Proposal for aligning CEVNI with SIGNI

Note of the secretariat

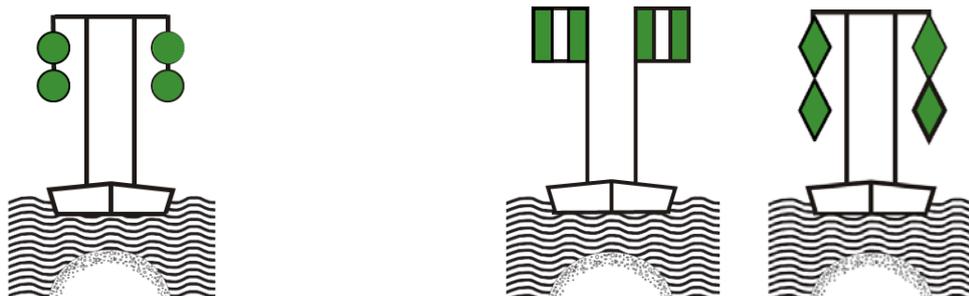
<i>Numbering</i>	<i>Signal</i>	<i>Description</i>	<i>Meaning</i>
D. Recommendatory signs			
D.2b ²		Two green lights set apart	“Go ahead between the lights”
D.1g ³		Single yellow light between green lights	“Go ahead, but look out for traffic coming the other way”. Vessels may steer towards the yellow light, which is placed above the navigable fairway
E. Informative signs			
E.1e		One red light and two green lights placed one above the other	“Pass only on the side showing two green lights”
E.1f		Two pairs of green lights placed one above the other	“Pass on either side”

The CEVNI Expert Group is invited to consider amending annex 7 to CEVNI with the following light signals. As an alternative, these signals mentioned in SIGNI can be additional to those in annex 7 to CEVNI.

(fig. 23 bis) »

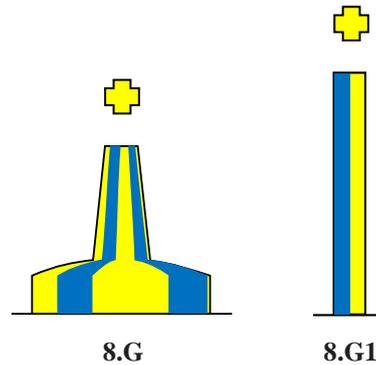
5. It is proposed to add a new para. 3 to sub-section A, section VI, annex 8 to CEVNI, introducing the new danger mark (ECE/TRANS/SC.3/WP.3/2017/5):

« 3. Marking of new dangers

Colour: Blue and yellow vertical stripes in equal number dimensions (minimum 4 stripes and maximum 8)

Form: pillar or spar

Topmark (if any): vertical or perpendicular yellow cross

Light (when fitted):

Colour: yellow/blue alternating

Rhythm: one second of blue light and one second of yellow light with 0.5 seconds of darkness

(fig.24 bis) »

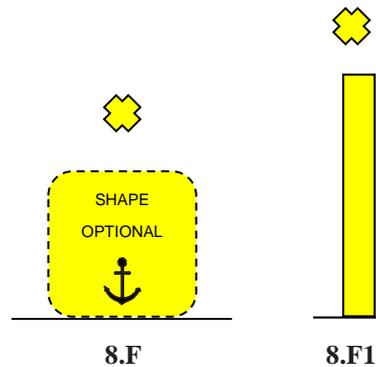
6. It is proposed to add a new sub-section B-bis after sub-section B, section VI, annex 8 to CEVNI (SIGNI, Revision 2, and ECE/TRANS/SC.3/WP.3/2017/5) :

« B BIS SPECIAL MARKS

Colour: yellow

Shape: optional, but not conflicting with navigational marks

Topmark if any: single yellow, "X" shape

Colour: yellow

Rhythm: any, other than those described in A.2, A.3 and B.
